## EXTRA SPACE SELF STORAGE JSP22-48

Public Hearing at the request of GHK, Inc. for approval of the Preliminary Site Plan, Special Land Use Permit, Wetland Permit, Woodland Permit, and Stormwater Management Plan. The subject property is approximately 4.3 acres and is located south of Nine Mile Road on the east side of Novi Road in the I-1, Light Industrial District. The applicant is proposing to renovate the existing building and build a new 3-story building to repurpose the site for an indoor climate-controlled self-storage facility.

**GHK Self-Storage; JSP22-48**  
**Wetland Review of Revised Preliminary Site Plan**  
MSG Project No. N1030138

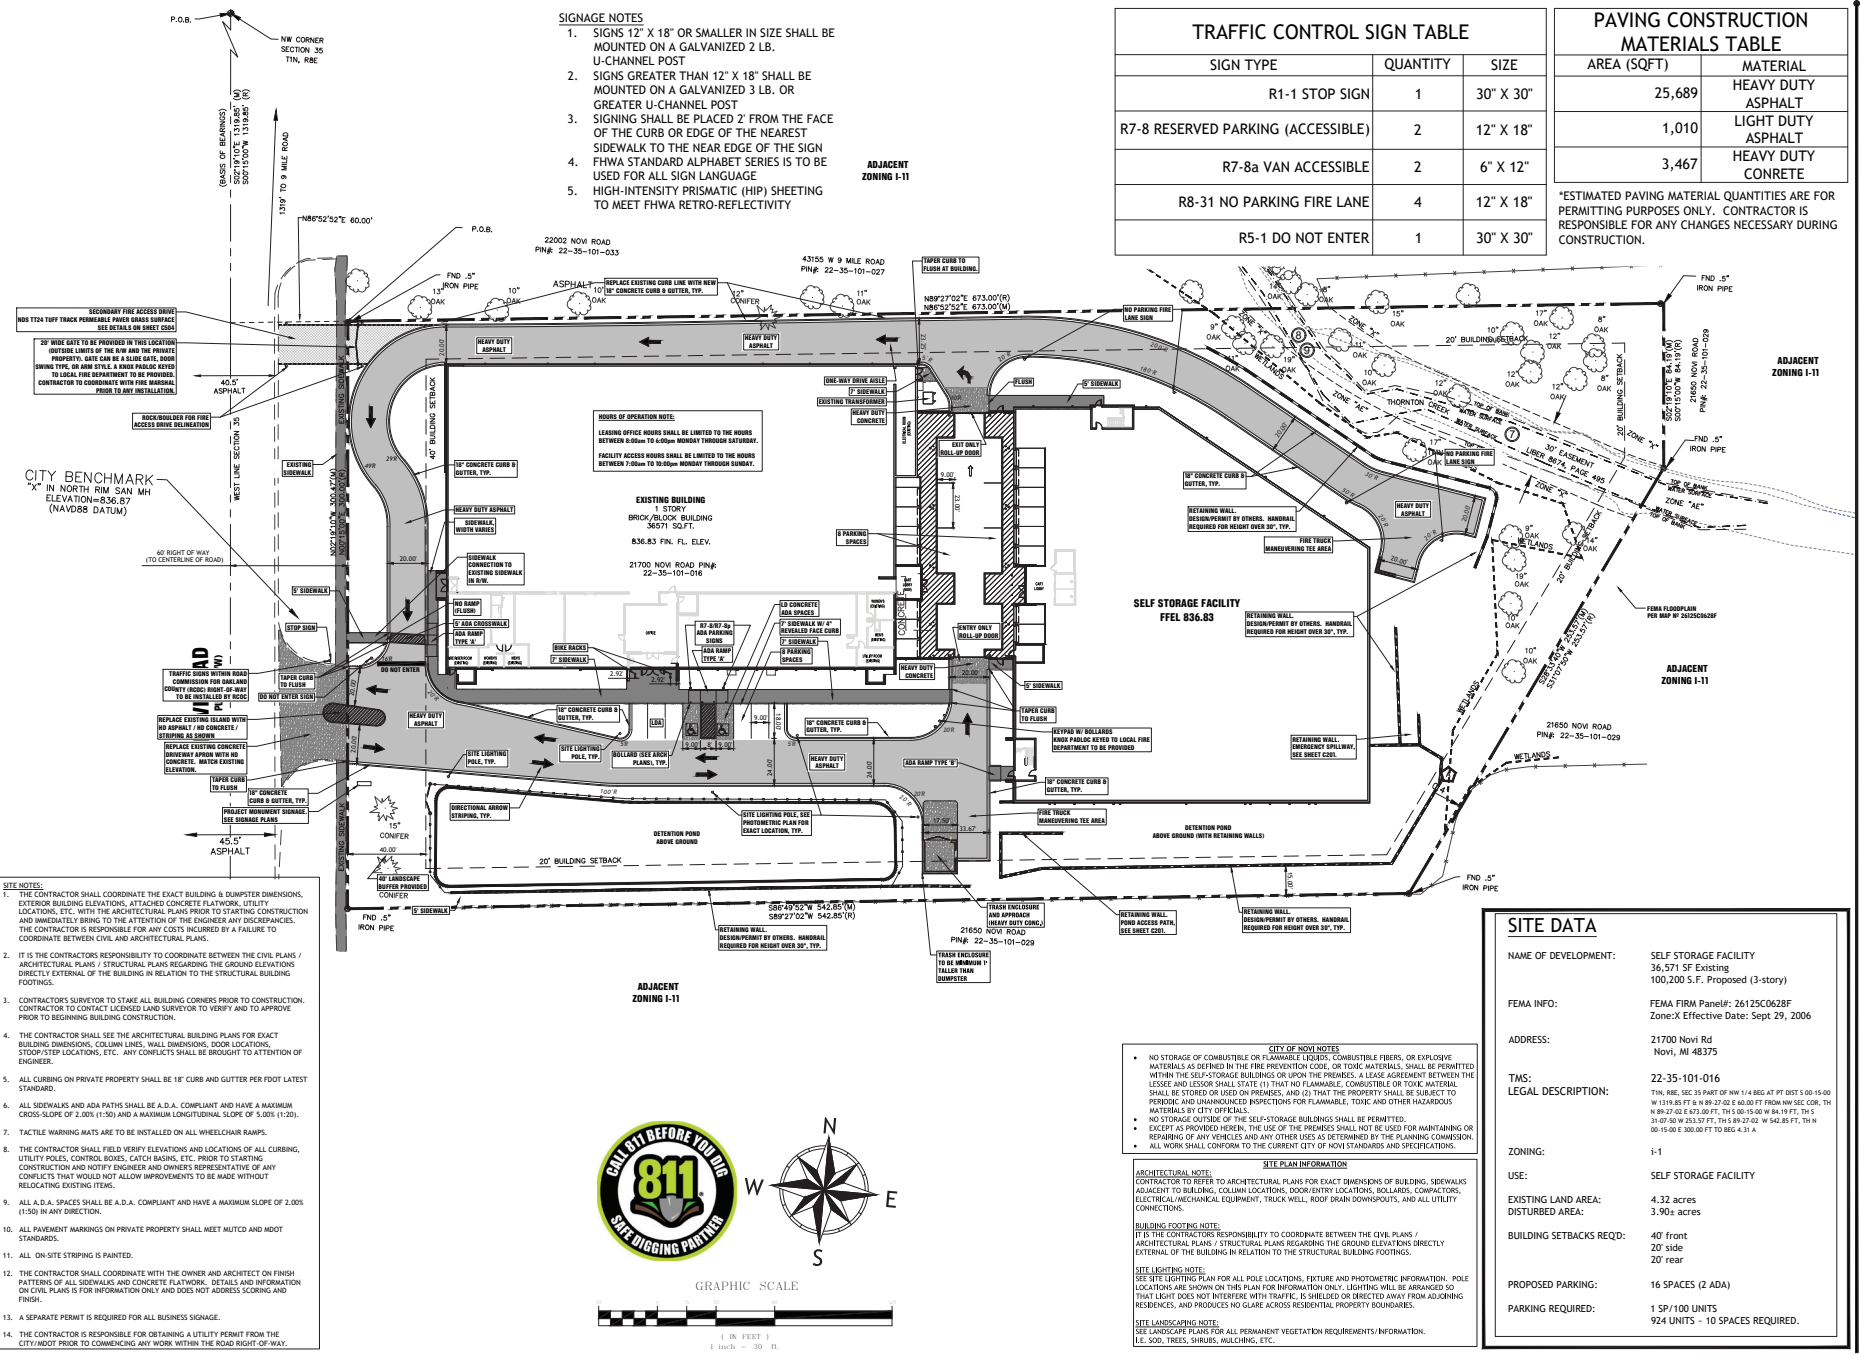
- **Corrected 4-17-23 KSP**-Sheet C101 – Front access drive indicates entrance(s) of 19.79' & 18.45'. This will need to be corrected to a minimum of 20' wide for Fire lane access.

WETLANDS / FLOOD PLAIN PLAN

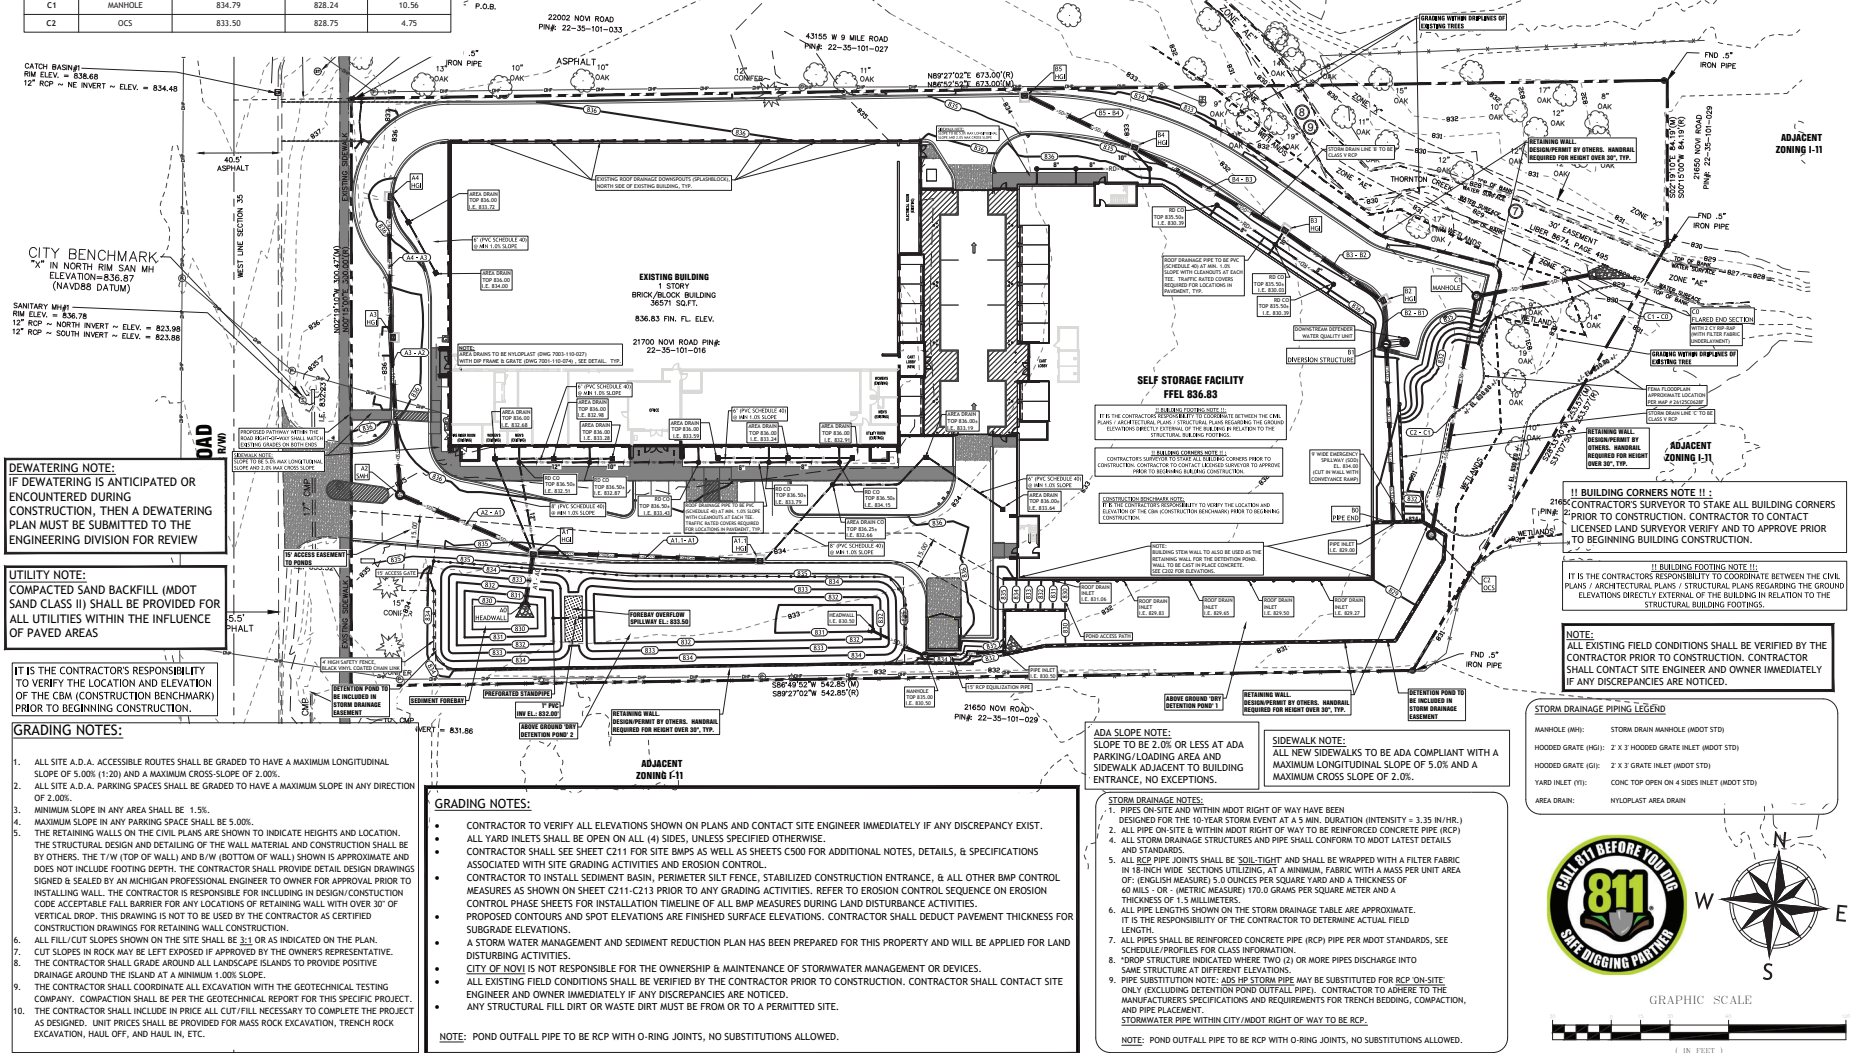
2. The wetland buffer cut/fill volumes are noted on Sheet C102 of the rPSP. The **areas** of permanent and/or temporary buffer impact also must be depicted and quantified on Site plans. Because the ground cover will be affected, areas where silt fence is to be installed are to be included in wetland buffer impact area calculations. This information is required for issuance of a Wetland Buffer Authorization letter.

2. The wetland buffer cut/fill volumes are noted on Sheet C102 of the rPSP. The **areas** of permanent and/or temporary buffer impact also must be depicted and quantified on Site plans. Because the ground cover will be affected, areas where silt fence is to be installed are to be included in wetland buffer impact area calculations. This information is required for issuance of a Wetland Buffer Authorization letter. **AREAS ADDED TO SITE PLANS**

DRAWING:  
**TREE PROTECTION AND REMOVAL PLAN**

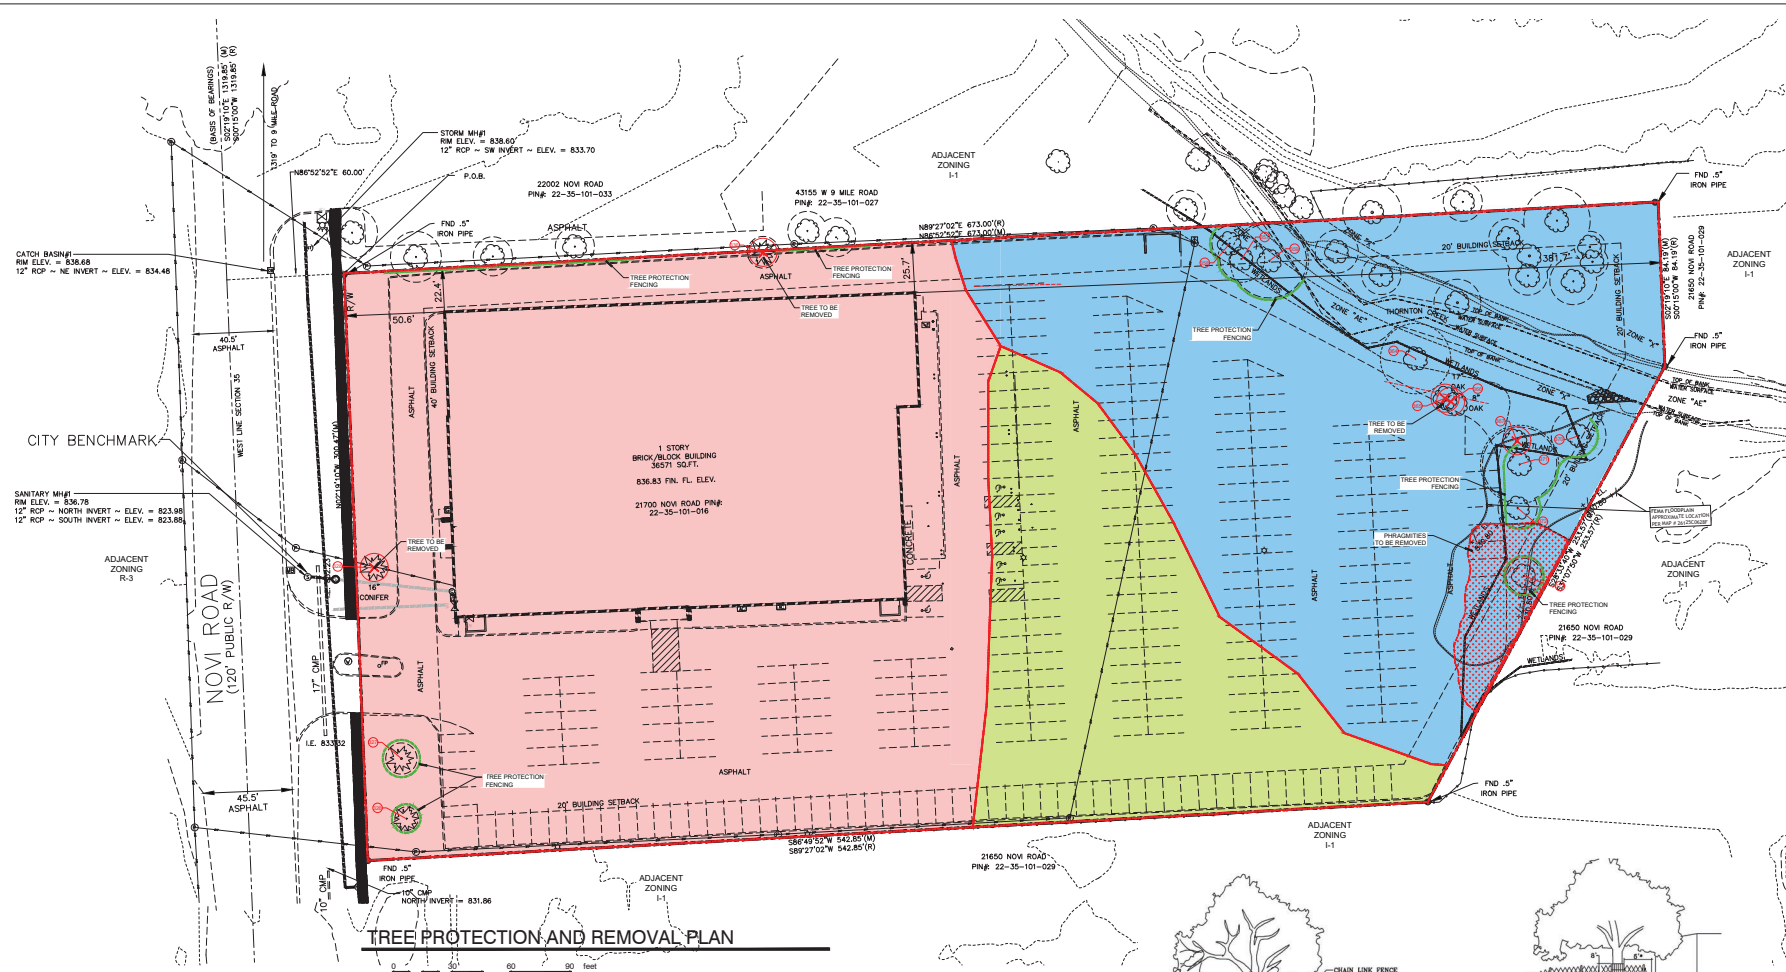
2. **Woodland Replacement Credits (Sheet LS-0).** The City of Novi Landscape Design Manual **allows non-regulated canopy trees that will be preserved** to be used to fulfill woodland replacement credits if they are on the site and not prohibited and/or invasive species.

The “Tree Removal/Protection Chart” on Sheet LS-0 **incorrectly shows regulated woodland trees** being saved and counted as woodland replacement credits. The following preserved regulated woodland trees **cannot be used towards meeting woodland replacement requirements:**

3. **Tree Removals and Replacements (Sheets LS-0/LS-1).** The plan proposes the removal of three (3) regulated woodland trees and impacts to the critical root zone one (1) regulated woodland tree which requires 8 woodland replacement credits (see chart below).

**Revise plans to fix the chart on sheet LS-0 to reflect the information in Comments 2 and 3.**

5. **Critical Root Zone (Sheet LS-0).** The tree protection fence diagrams on sheet LS-0 state the wrong information regarding measurement of the critical root zone. **Revise drawings to use the definition from Chapter 37.**

OVERALL LANDSCAPE PLAN (TREES)

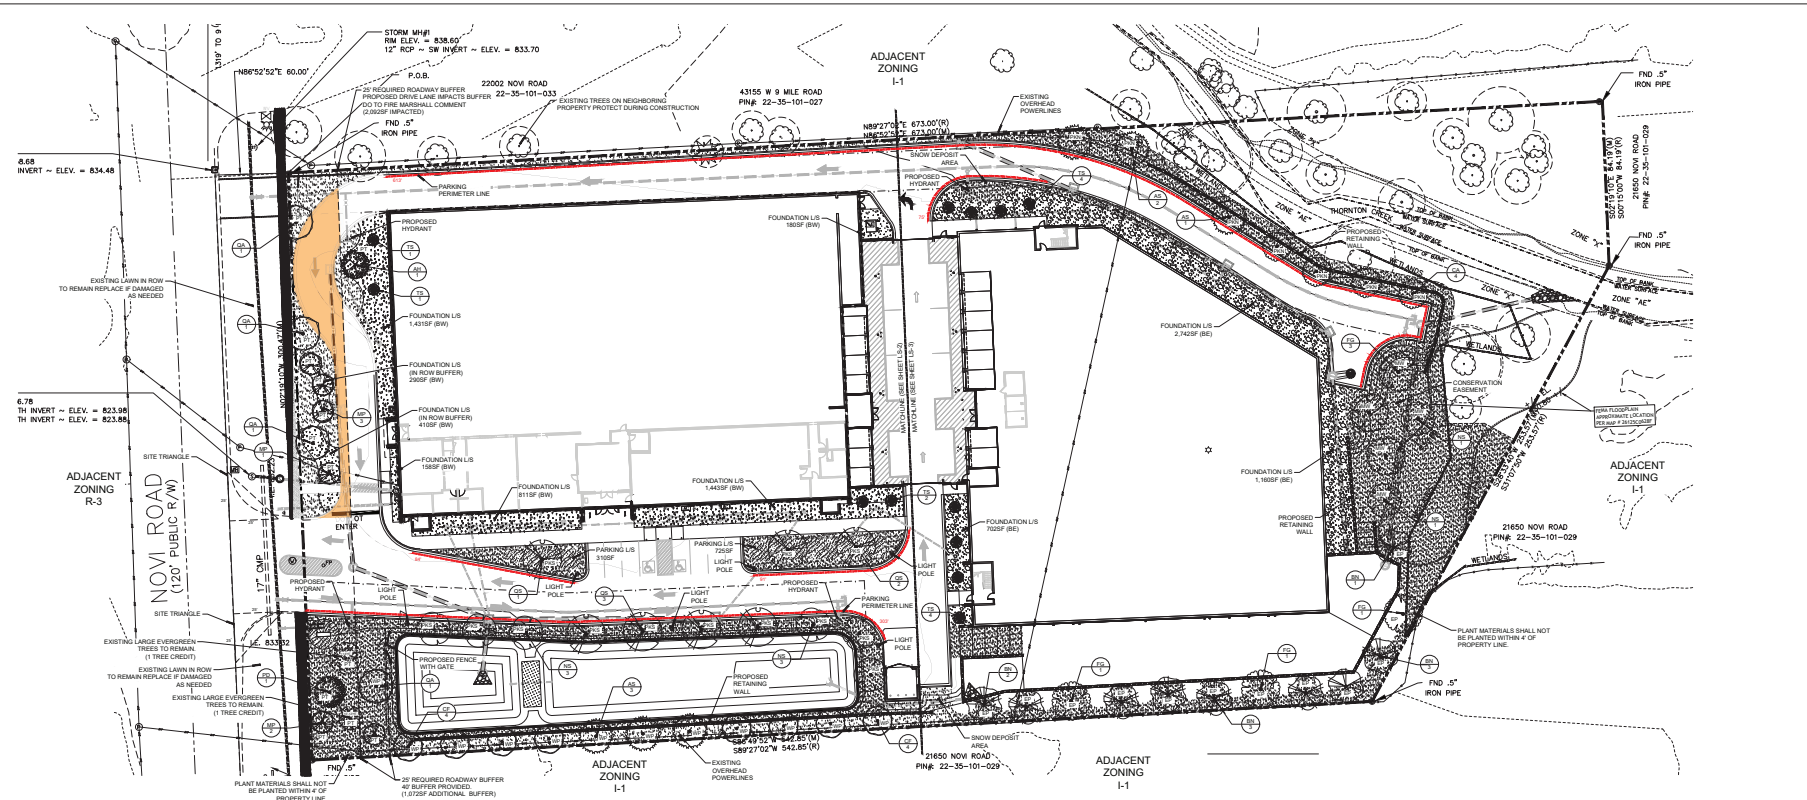
4. **Woodland Replacements (Sheet LS-1).** The site is required to mitigate the removal/disturbance of the 4 regulated woodland trees through the preservation of two non-regulated trees and with **eight (8) woodland replacement credits**. Woodland replacement credits can be provided by:
  - a. Planting the woodland tree replacement credits on-site.
  - b. Payment to the City of Novi Tree Fund at a rate of \$400/woodland replacement credit.
  - c. Combination of on-site tree planting and payment into the City of Novi Tree Fund (\$400/woodland replacement credit).
